Project	IEEE 802.16 Broadband Wireless Access Working Group < http://ieee802.org/16 >
Title	Flexible Frequency Reuse Operation
Date Submitted	2004-06-25
Source(s)	Jeong-Heon Kim, Panyuh Joo, Seung Joo Maeng, Jaeho Jeon, Soon Young Yoon Samsung Electronics Co., Ltd.
Re:	Contribution supporting Sponsor ballot
Abstract	Frequency reuse factor of 1 and non-one frequency reuse factor support at the same time
Purpose	Adoption of suggested changes into P802.16e/D3
Notice	This document has been prepared to assist IEEE 802.16. It is offered as a basis for discussion and is not binding on the contributing individual(s) or organization(s). The material in this document is subject to change in form and content after further study. The contributor(s) reserve(s) the right to add, amend or withdraw material contained herein.
Release	The contributor grants a free, irrevocable license to the IEEE to incorporate material contained in this contribution, and any modifications thereof, in the creation of an IEEE Standards publication; to copyright in the IEEE's name any IEEE Standards publication even though it may include portions of this contribution; and at the IEEE's sole discretion to permit others

Figure 1 structure of downlink/uplink when type I scheme is applied

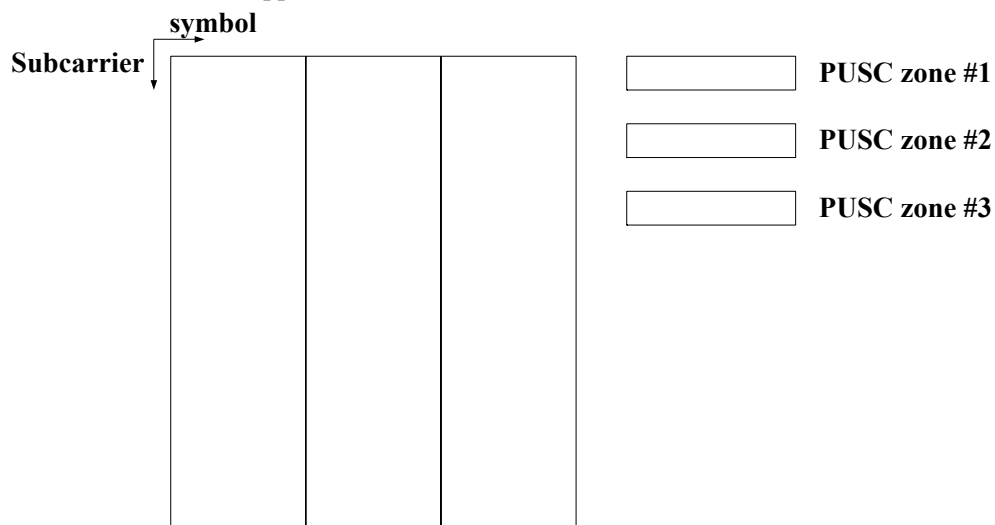
The current FUSC permutations can be candidates. In order for those FUSC permutations to be used in a partial usage manner some fraction of total symbols are partitioned into segments which can be called “PUSC zones” and each PUSC zone is used exclusively in each sector or each BS. Figure 1 shows an example of basic downlink or uplink structure when the above scheme is applied.

Subcarrier allocation for PUSC type I is depicted in Figure 1. Each PUSC zone is allocated a disjoint set of symbols. In each PUSC zone, Subcarrier allocation is the same as optional FUSC in section 8.4.6.1.2.3 and the permutation formula in section 8.4.6.1.2.3.1 shall be used.

Subcarrier allocation for PUSC type I is depicted in Figure 1. Each PUSC zone is allocated a disjoint set of symbols. In each PUSC zone, Subcarrier allocation is the same as optional PUSC in section 8.4.6.2.5 and the permutation formula in section 8.4.6.2.5.2 shall be used.

Figure 2 Basic structure of downlink/uplink when type II scheme is applied

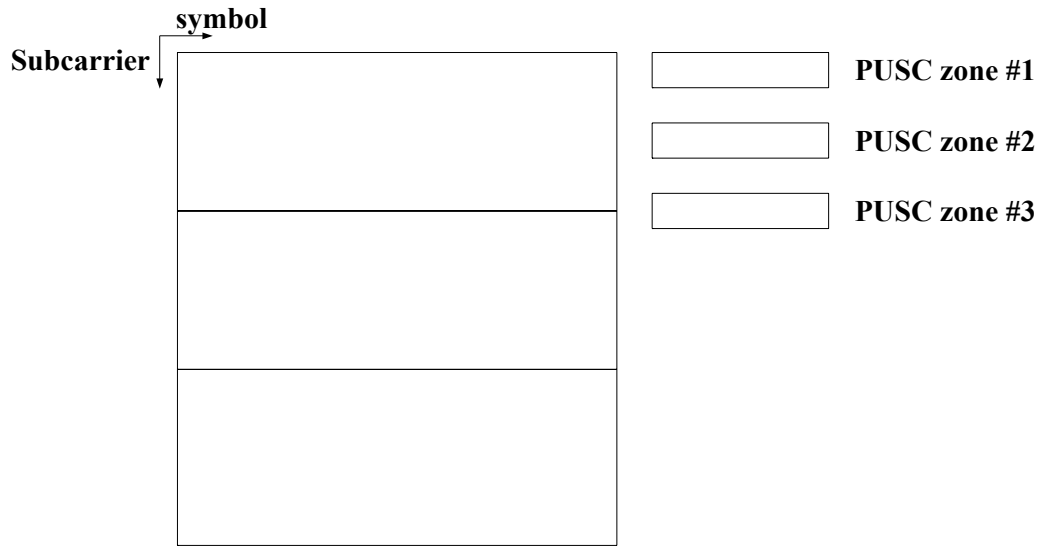
The method 1 divides the resources through time axis to provide partial usage mannered permutation zone. So called “PUSC zones” can be provided by dividing the resource through frequency axis which is the case in the currently supported schemes in 802.16 REVd/D5 and 802.16e/D3. The basic concept is depicted in Figure 2. In each PUSC zone, scattered carrier permutation scheme will be applied in order to provide frequency diversity.

Figure 3 Basic structure of downlink/uplink when a type III scheme is applied

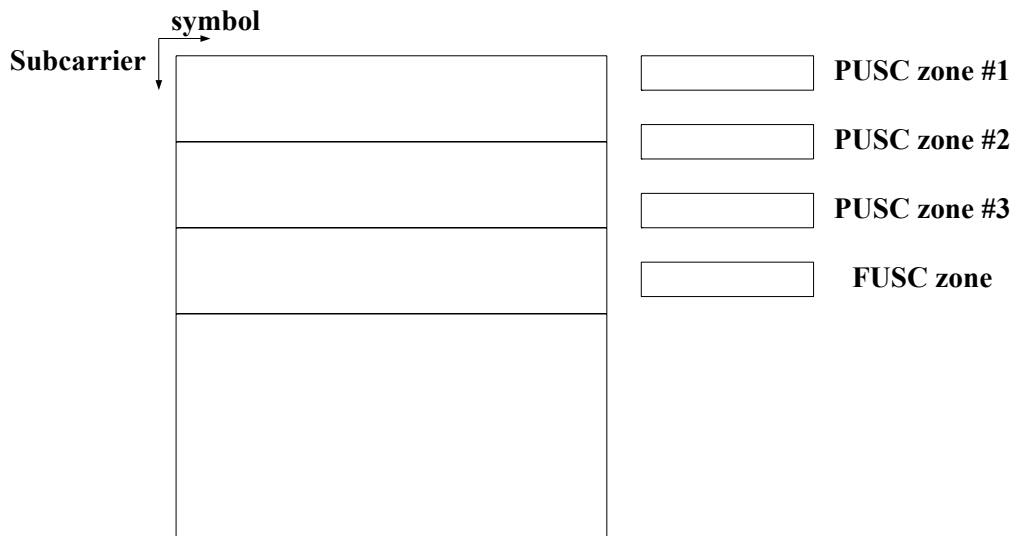
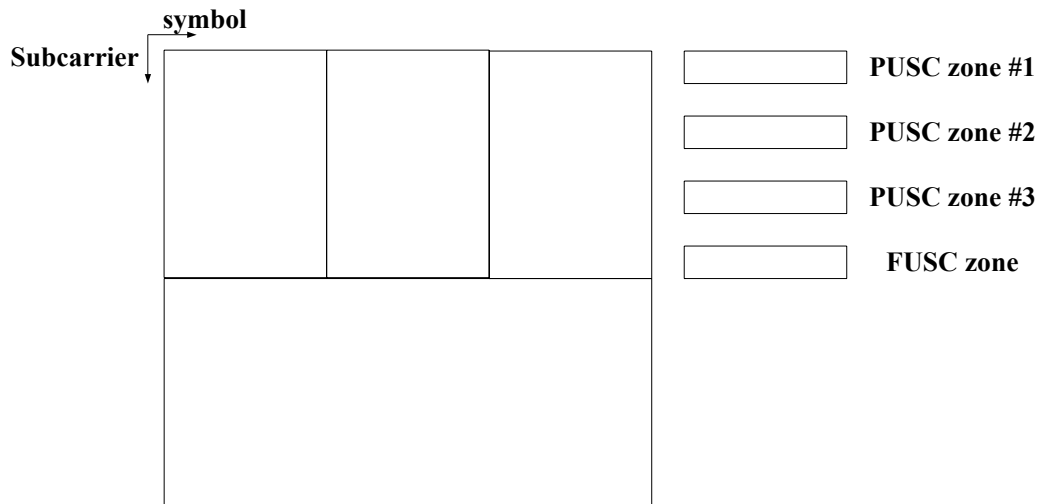
One more possibility is the mixed structure of method 1 and 2. That is, “PUSC zones” are constructed by dividing resources through time and frequency axis. This scheme can give more flexibility to resource allocation.

Figure 4 Subcarrier allocation for PUSC type II

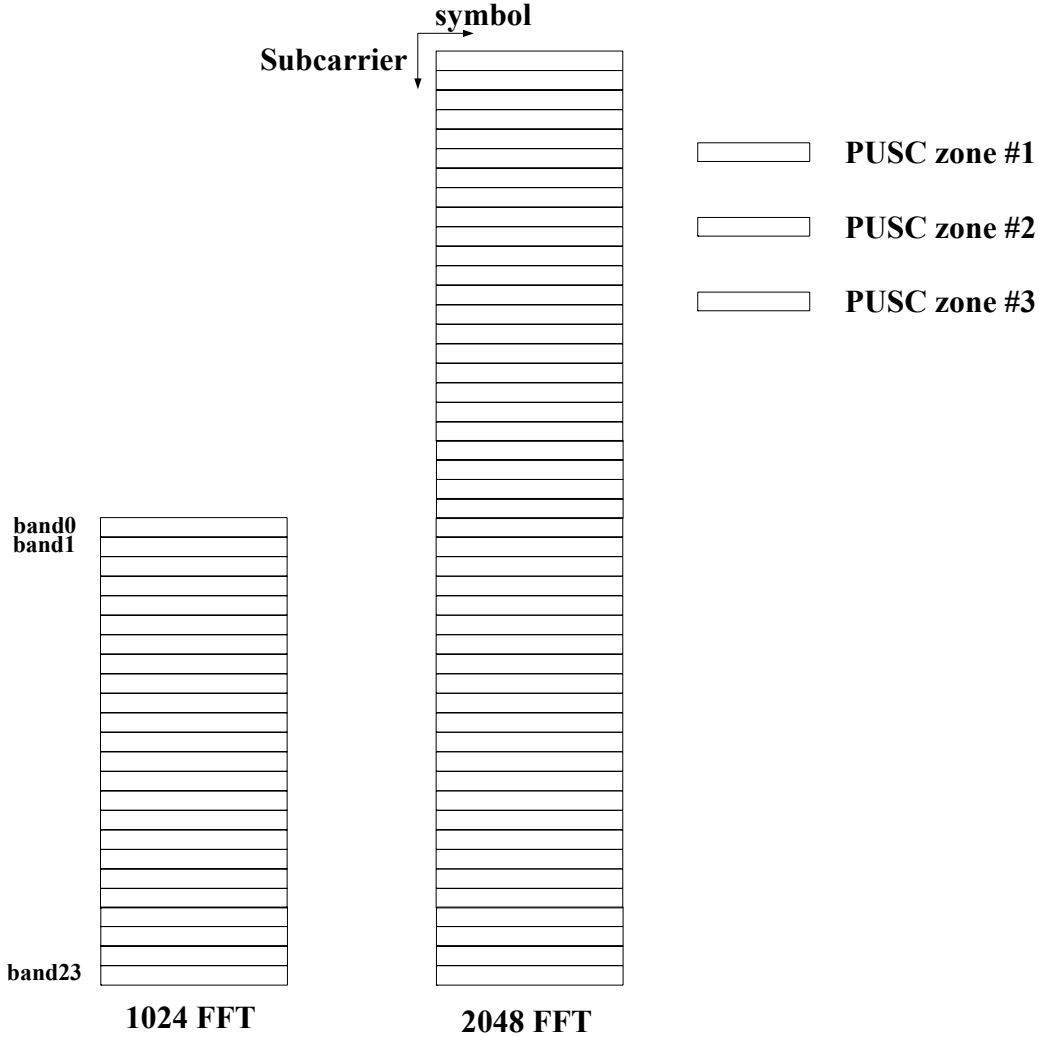
Subcarrier allocation for PUSC type II is depicted in Figure 4. A bunch of 9 contiguous subcarriers containing 1 pilot carrier and 8 data carriers is called a bin and 4 consecutive bins are called a band. Those bands are divided into three segments each of which is assigned to a PUSC zone.

For PUSC type II operation, total bands are partitioned into 3 segments and subchannel subcarrier allocation is done in each segment. The partition into 3 segments is shown in Figure 4. To allocate the diversity subchannels, data tones in 3 consecutive symbols in a segment are partitioned into 48 groups of contiguous data subcarriers. Each subchannel consists of one subcarrier from each of these groups. The exact partitioning into subchannels is according to the permutation formula in section 8.4.6.1.2.3.1. If FFT size is 1024, then N_s is 16. If FFT size is 2048, then N_s is 32. The basic permutation sequences P_1 and P_2 are shown in Table 309a. The enumeration of the subcarriers in a segment within three symbols starts from the lowest numbered data subcarrier of the first symbol in a segment and goes to the next carriers. If it reaches the last carrier in the symbol in the segment, it goes to the lowest data carrier of the next symbol and so on.

Figure 5 subcarrier allocation for PUSC type III-A

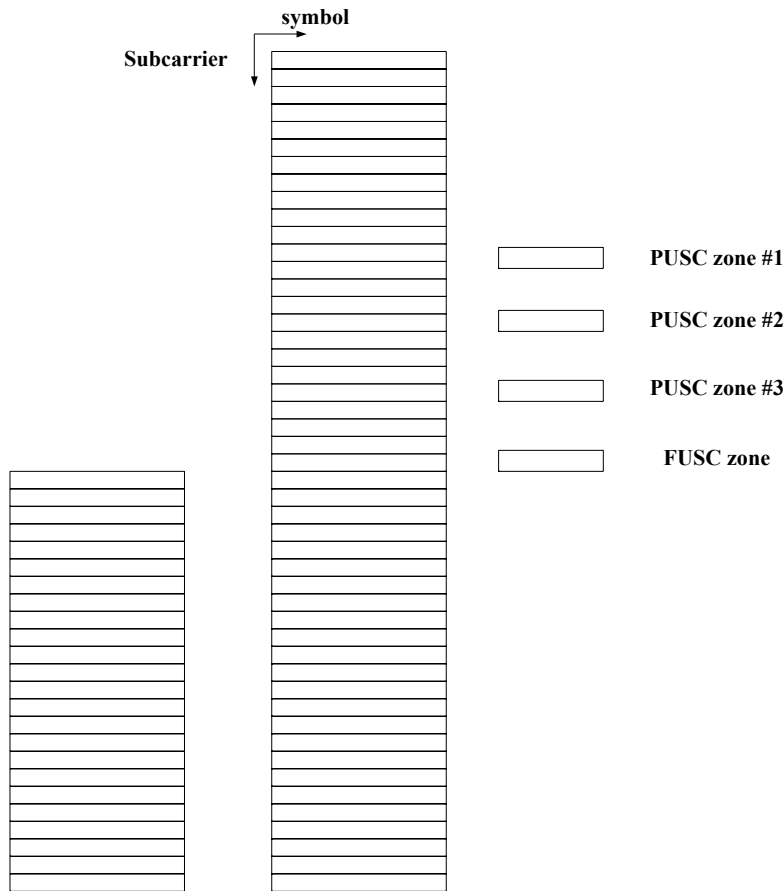
For 2048 FFT, N_{used} subcarriers are divided into 48 bands of contiguous subcarriers which are indexed from 0 to 47. Even numbered bands are used for FUSC and odd numbered bands are used for PUSC. 24 bands for PUSC are divided into 3 segments, which are used for different sectors respectively. The subcarrier allocation for FUSC + PUSC operation is described in Table 4. Similar subcarrier allocation for 1024 FFT is shown in Table 5.

Figure 6 Subcarrier allocation for PUSC type III-B in 1024 FFT

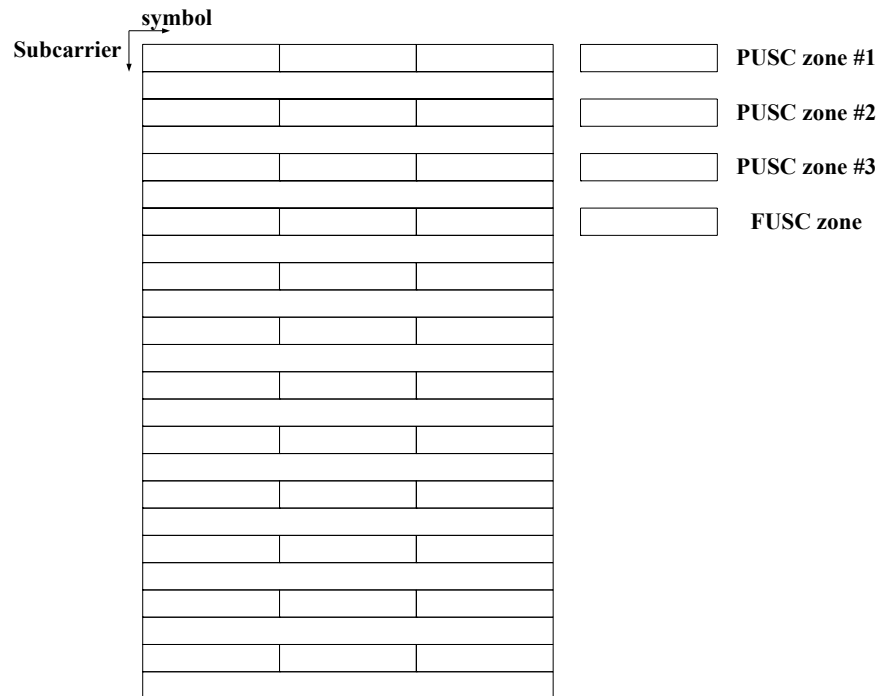
For 2048 FFT, N_{used} subcarriers are divided into 48 bands of contiguous subcarriers which are indexed from 0 to 47. Even numbered bands are used for FUSC zone and odd numbered bands are used for PUSC zone. The partition of subcarriers in three symbols is shown in Figure 6. The subcarrier allocation for PUSC type III-B operation is described in Table 10. Similar subcarrier allocation for 1024 FFT is shown in Table 11.
